RE: Case #10-02-PD, a request for a Planned Development at the northwest corner of Highways 183 and 360, extending north to Harwood Road, and named Riverwalk At Eules.

The Dallas/Fort Worth International Airport Board ("DFW") opposes the proposed planned development referenced above for the reasons presented below.

RIVERWALK AT EULESS PROPOSAL

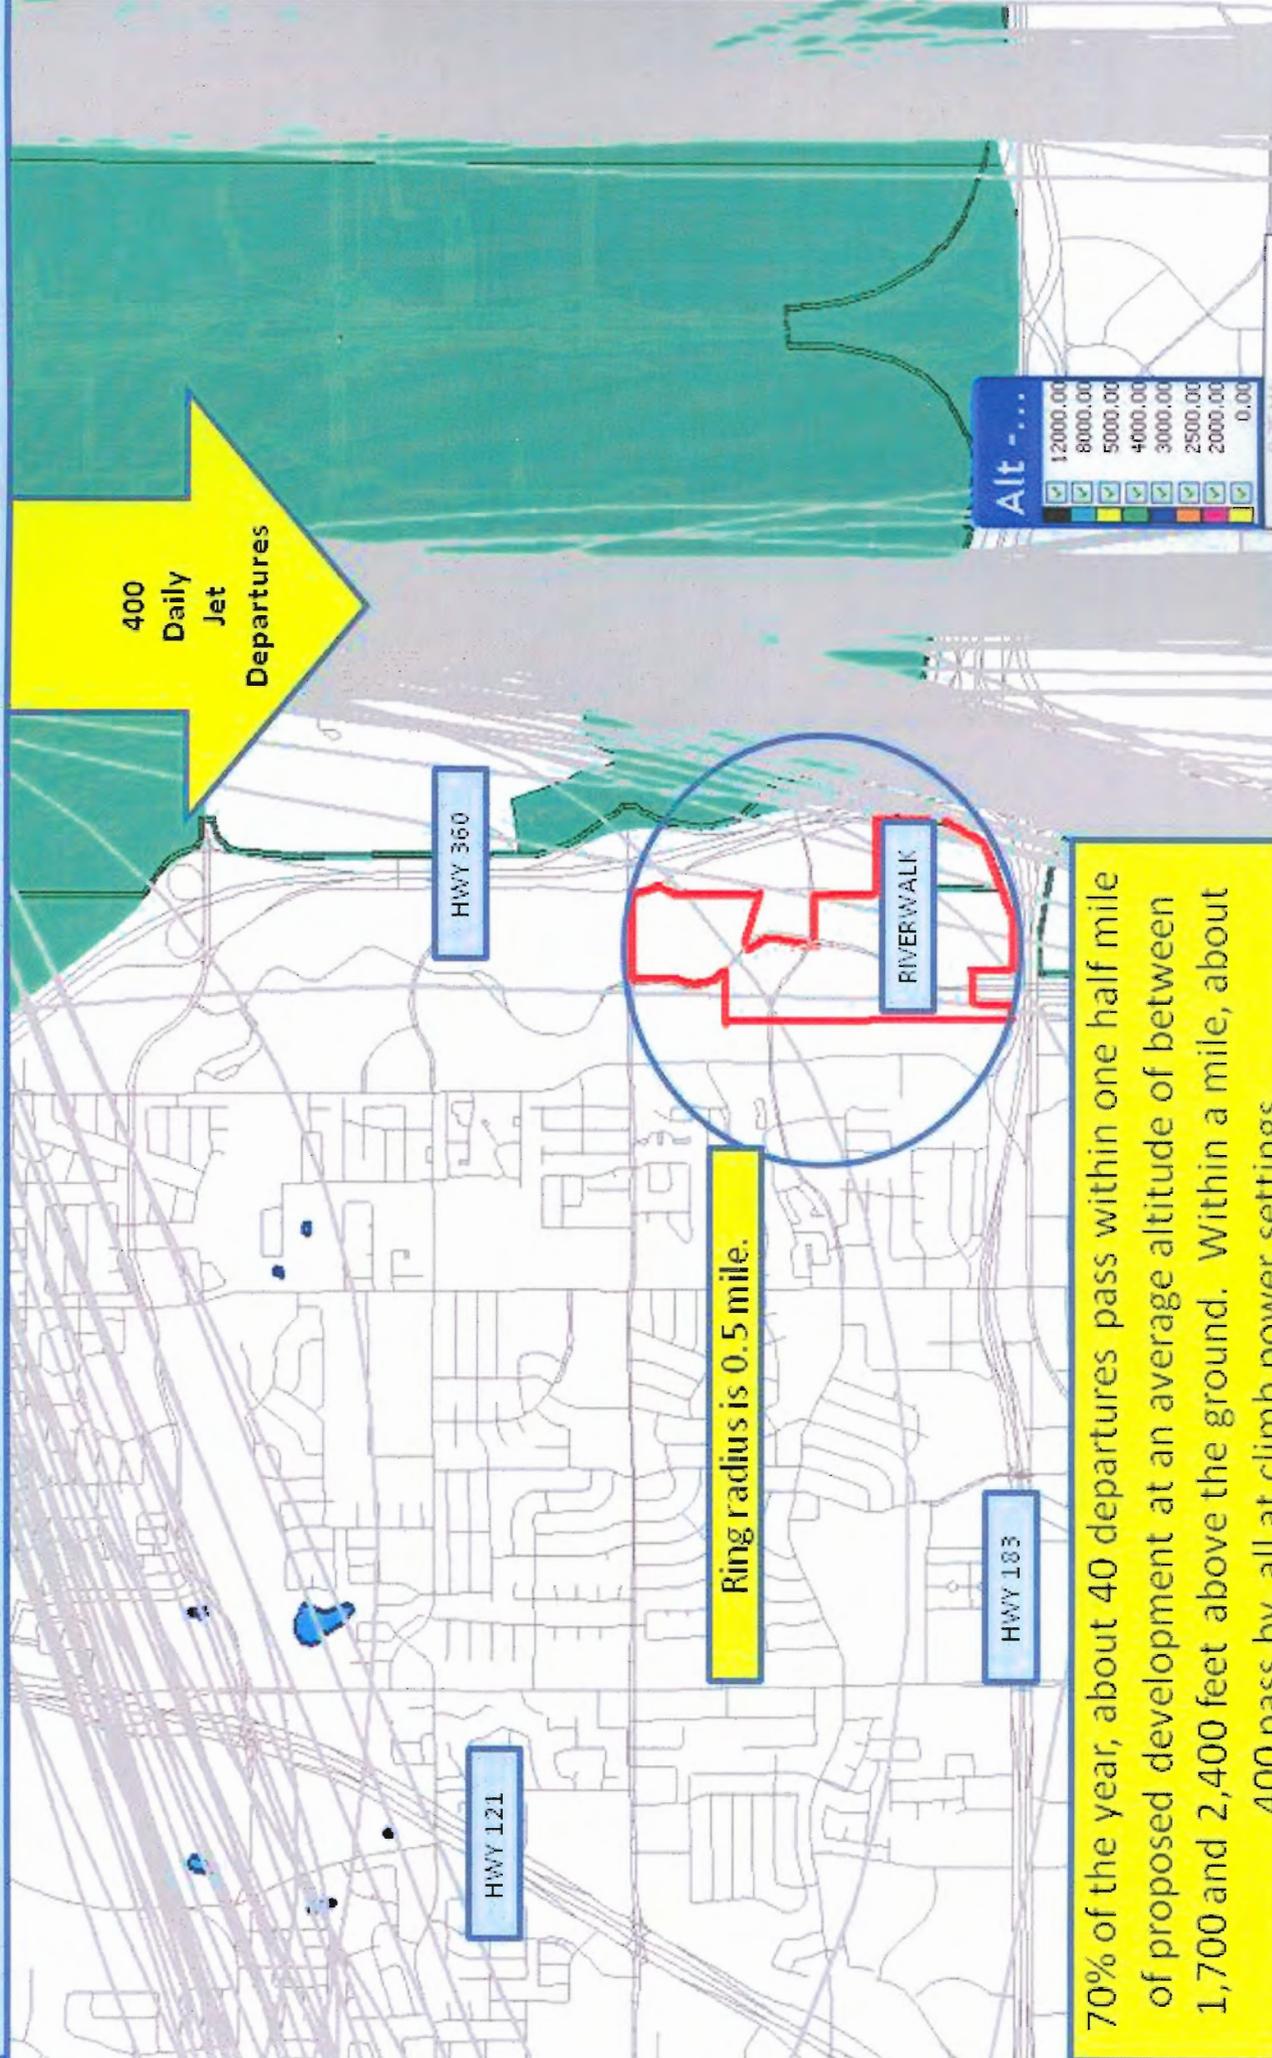
70% of the year, about 40 departures pass within one half mile of proposed development at an average altitude of between 1,700 and 2,400 feet above the ground. Within a mile, about 400 pass by, all at climb power settings.

RIVERWALK AT EULESS PROPOSAL

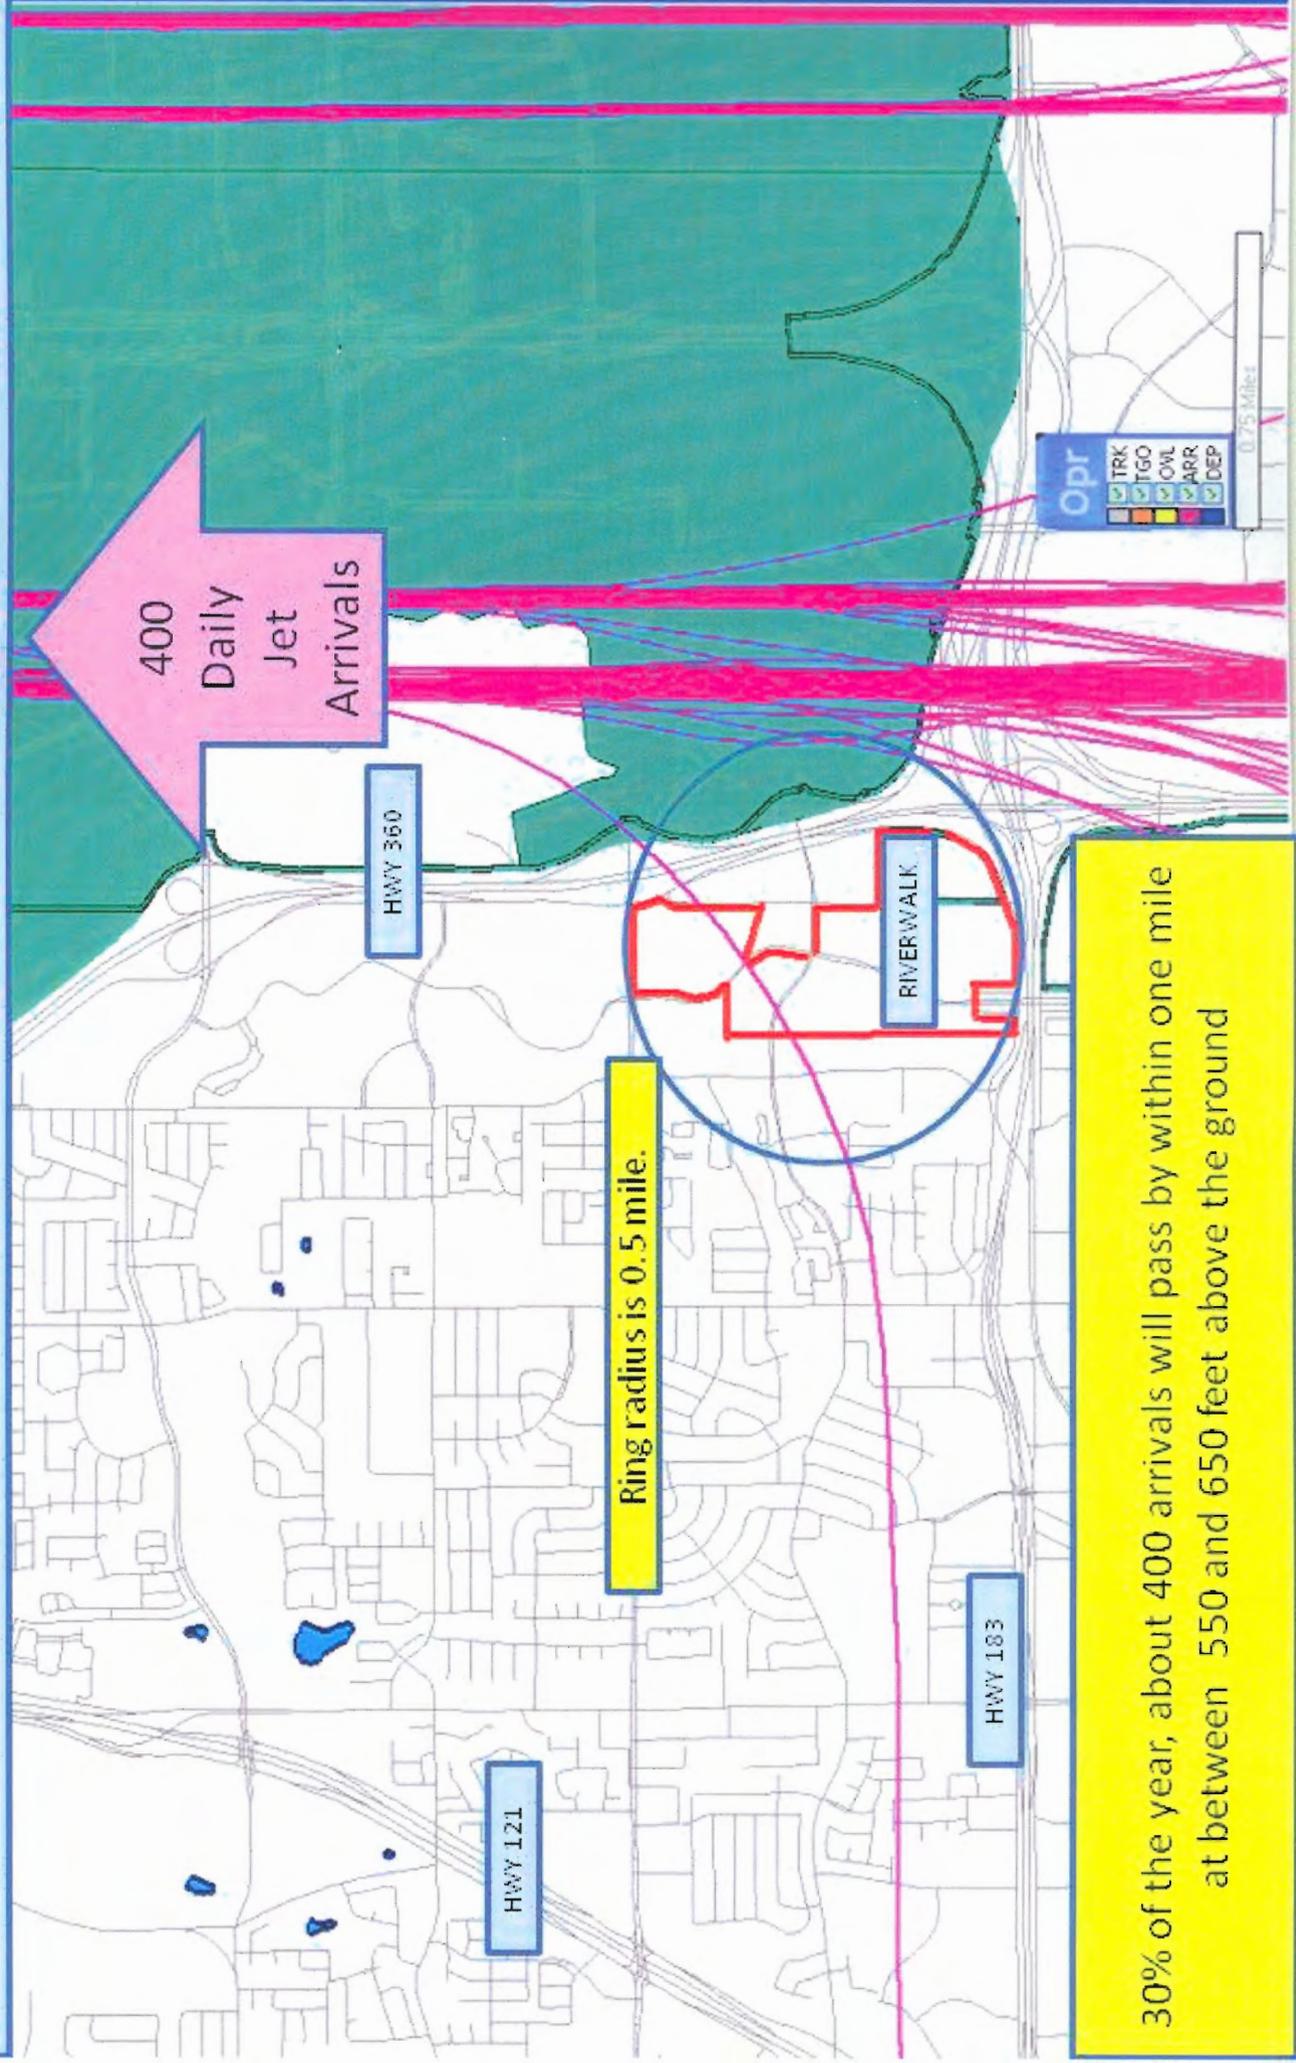
30% of the year, about 400 arrivals will pass by within one mile at between 550 and 650 feet above the ground
